## ECN

### Mini-ITX Industrial Chassis

ECN-No. SBOEM-MinCha-020614

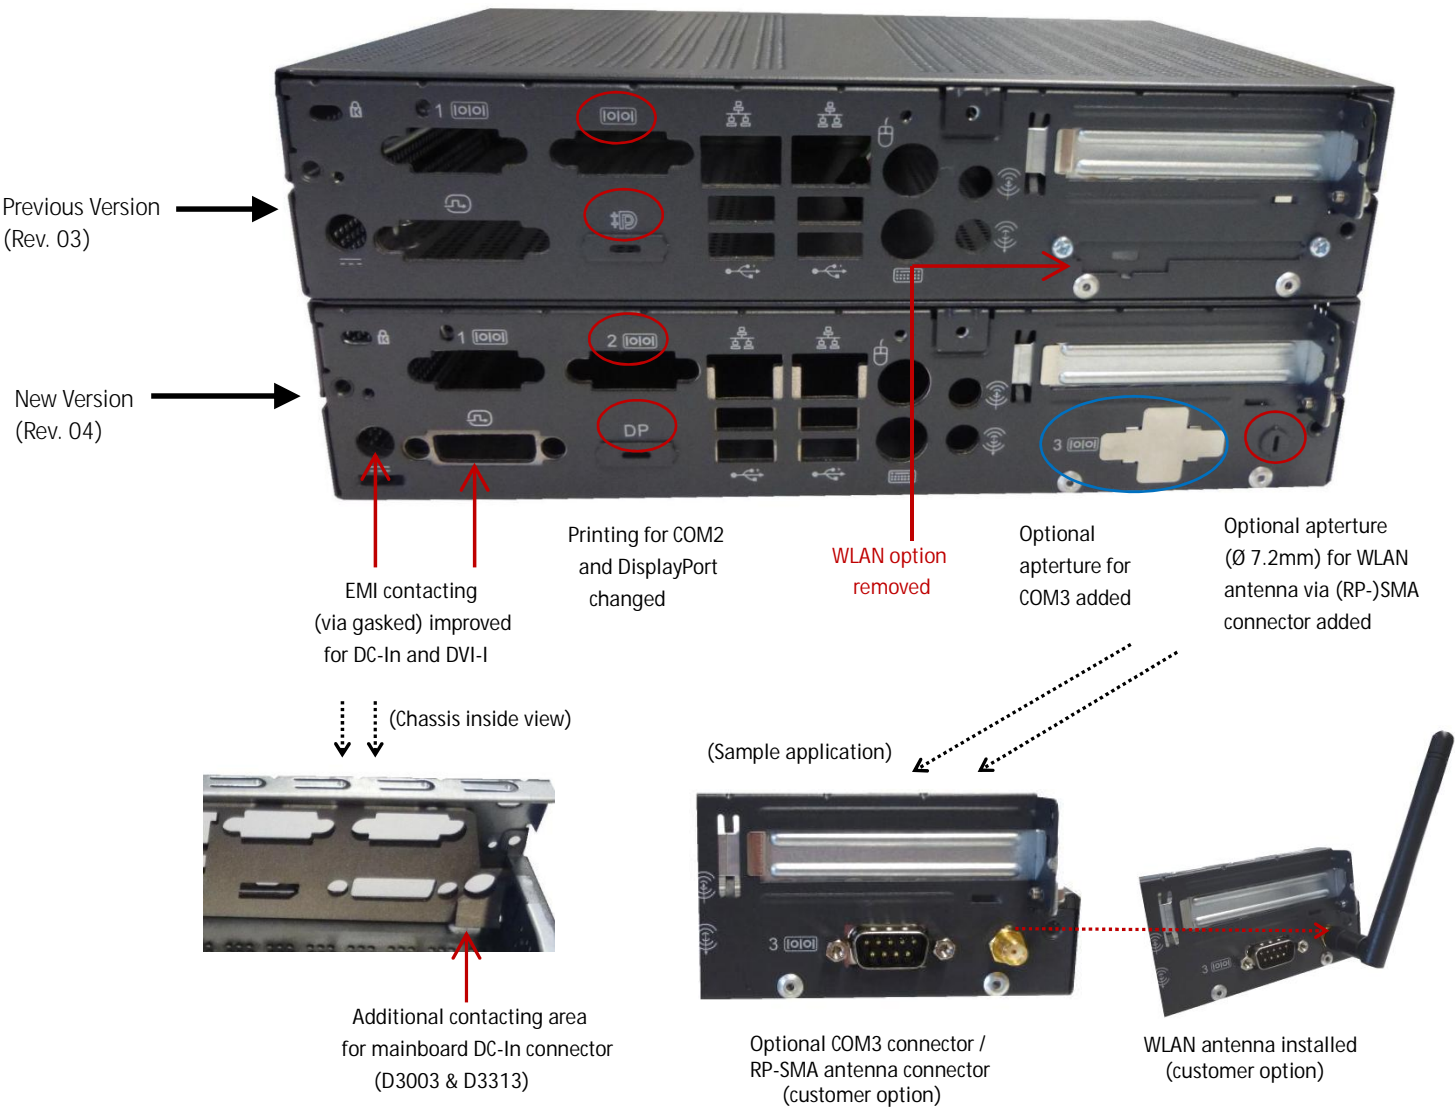
- Reason for ECN:
- Remove support for internal WLAN module (EoL of AzureWave Module)
  - Provide option for additional COM connector
  - Provide mounting option for WLAN antenna via (RP-) SMA connector
  - Improve EMI for D3313-S
  - Adjust connector labeling (printing)
- See next page for details!

Current Part No. / Revision	New Part No. / Revision
S26361-F5000-J002 / Rev. 03	S26361-F5000-J002 / Rev. 04

Note: Part number remains unchanged!
